SAFETY EVALUATION BY OFFICE OF NUCLEAR REACTOR REGULATION

SUPPORTING AMENDMENT NO. 68

TO FACILITY OPERATING LICENSE NO. DPR-54

RANCHO SECO NUCLEAR GENERATING STATION

FIGURE 3  
FINAL A. C. SYSTEMS

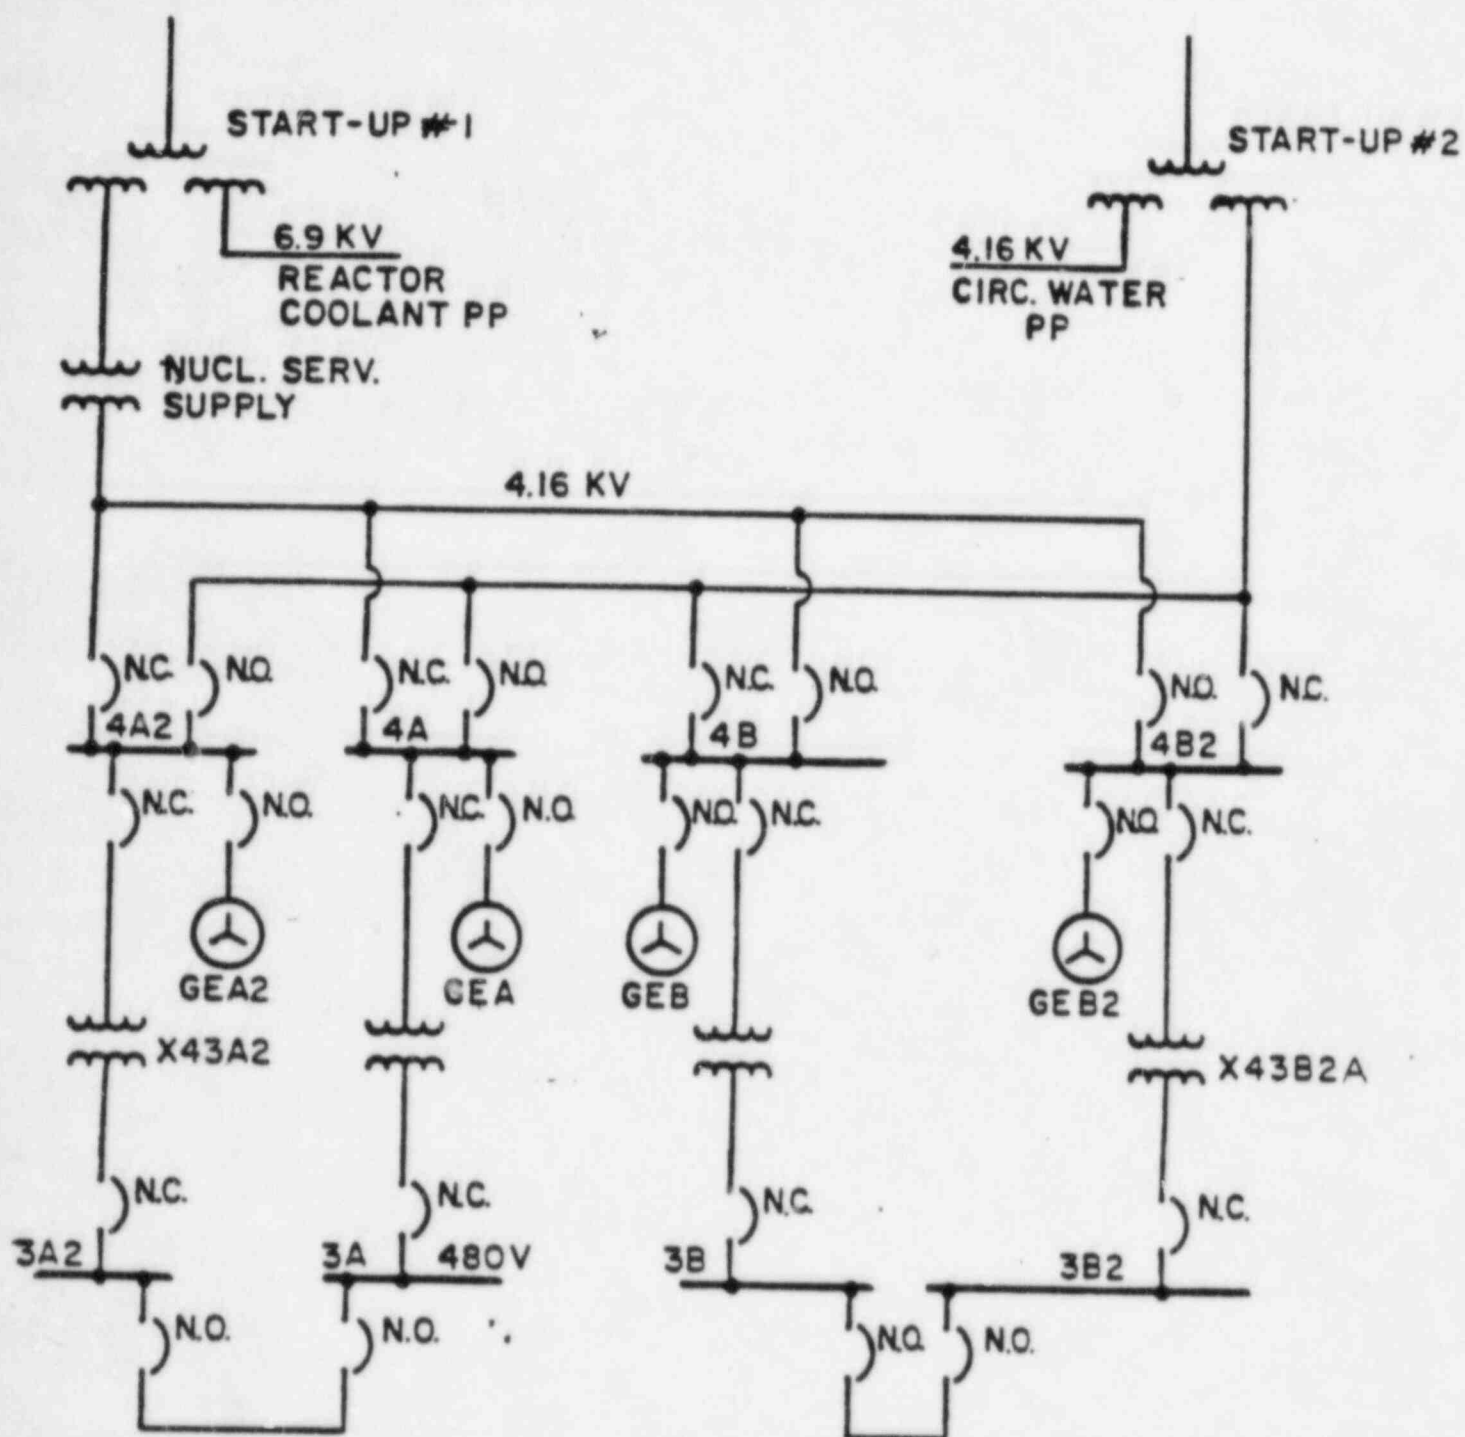
As shown in Figure 3, in the event of a loss of offsite power, all loads on buses 3A/3A2 and 3B/3B2 will be supplied via transformers X43A1 and X43B2A respectively. The acceptability of this mode of operation is therefore dependent on the load carrying capacity of these transformers relative to safety-related loads.

FIGURE 6  
INTERIM SYSTEM - CYCLE 7

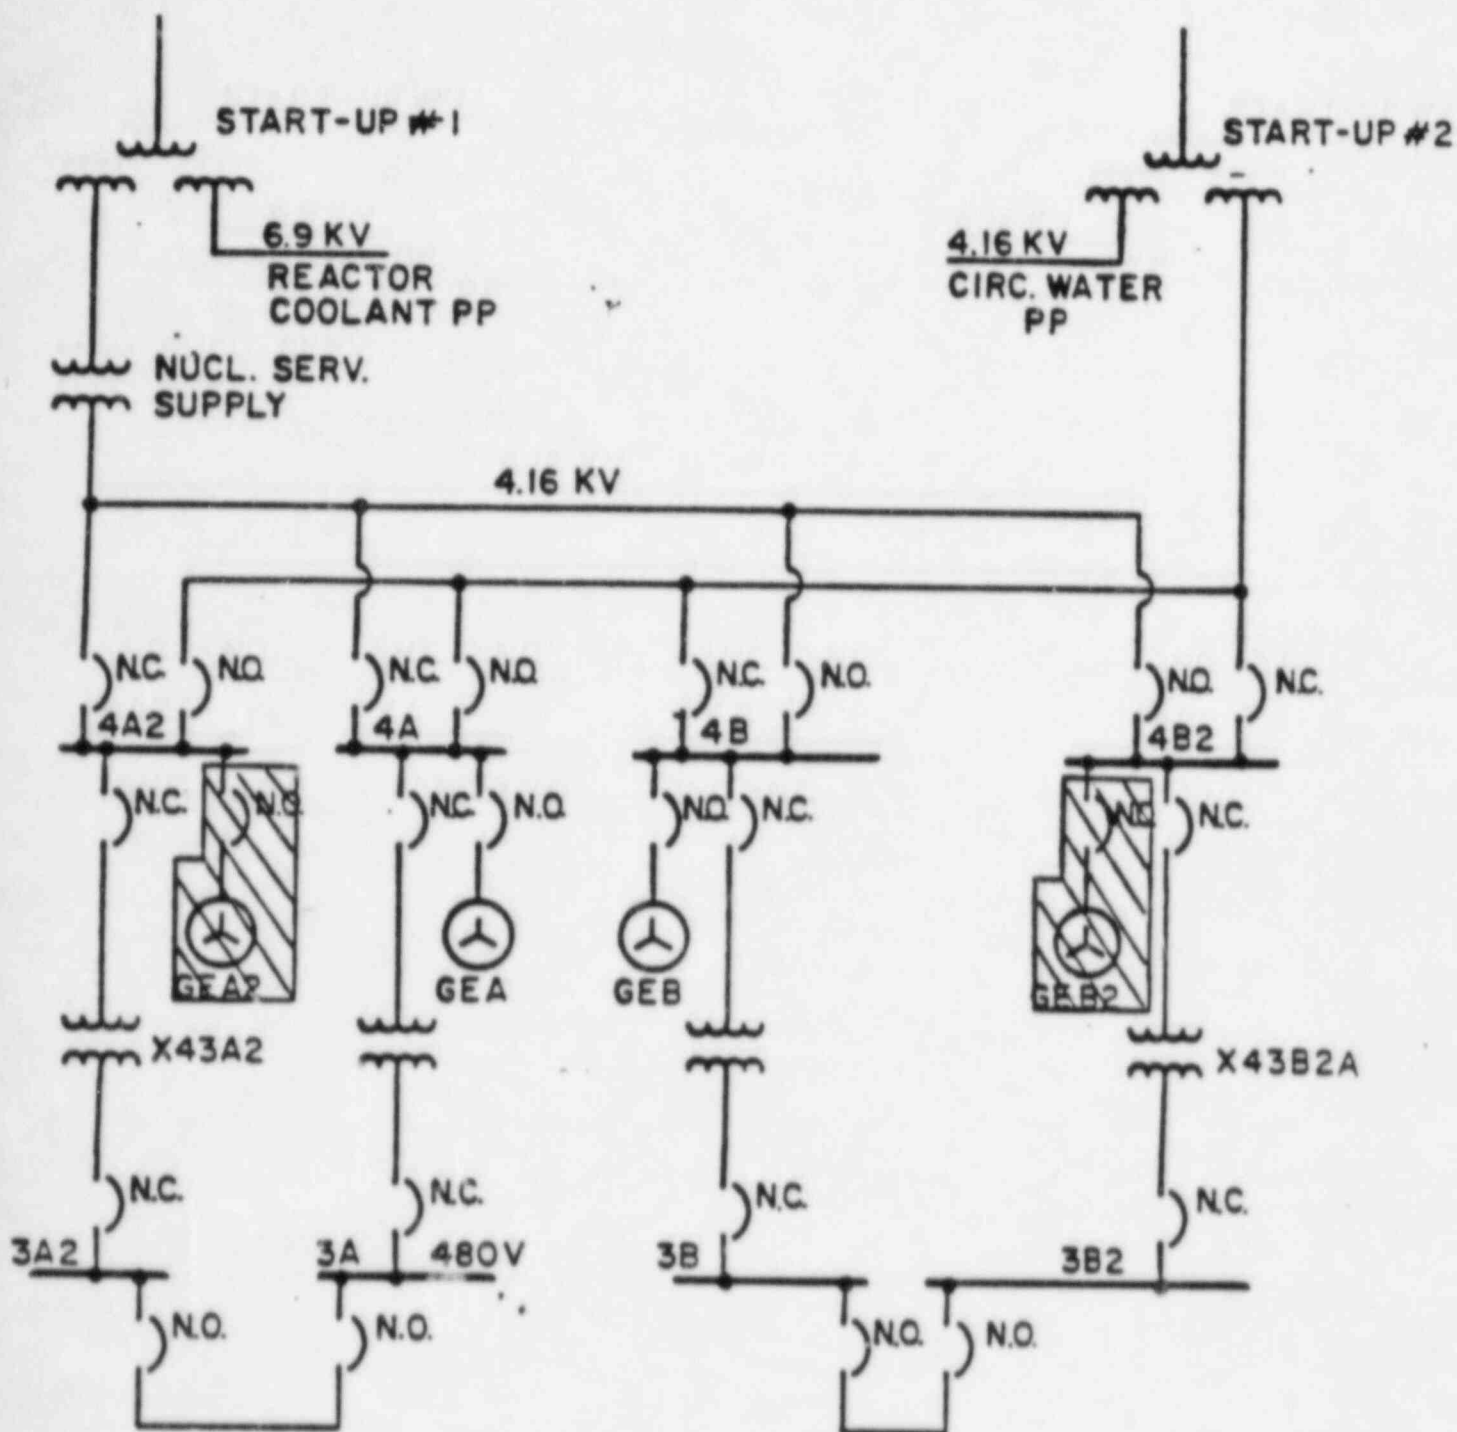
Figure 6 shows the proposed operational configuration when there is not a loss of offsite power. It is seen that for this configuration, the 4160 volt buses of the "A" train (buses 4A and 4A2) are individually powered from Startup Transformer No. 1, and the corresponding buses of the "B" train are powered from Startup Transformer No. 2. Power to new 480 volt bus 3A2 is supplied from new 4160 volt bus 4A2 via new transformer X43A2. A similar arrangement is seen to be employed for the "B" train via new transformer X43B2A.

For a loss of offsite power (LOOP) condition, the arrangement in Figure 6 is changed by the automatic opening of the circuit breakers supplying power to buses 4A, 4B, 4A2, 4B2, 3A2 and 3B2. Under these conditions, power is automatically supplied to buses 4A and 3A and buses 4B and 3B by diesel generators GEA and GEB respectively. Train "B" sequencing will include automatic closure of the Class 1E train "B" electrical cable tie breakers between the old 480 volt switchgear 3B and the new 480 volt loadcenter 3B2, thereby energizing bus 3B2. This sequencing will also automatically re-energize the train "B" Control Room essential HVAC which is supplied from bus 3B2. The operator will manually close the train "A" Class 1E electrical cable tie breakers between the old 480 volt switchgear 3A and the new 480 volt loadcenter 3A2. Automatic loading of bus 3B2 is provided as an interim measure (pending qualification of new diesel generators GEA2 and GEB2) to retain the current capability for automatic restoration of power to the Control Room HVAC.
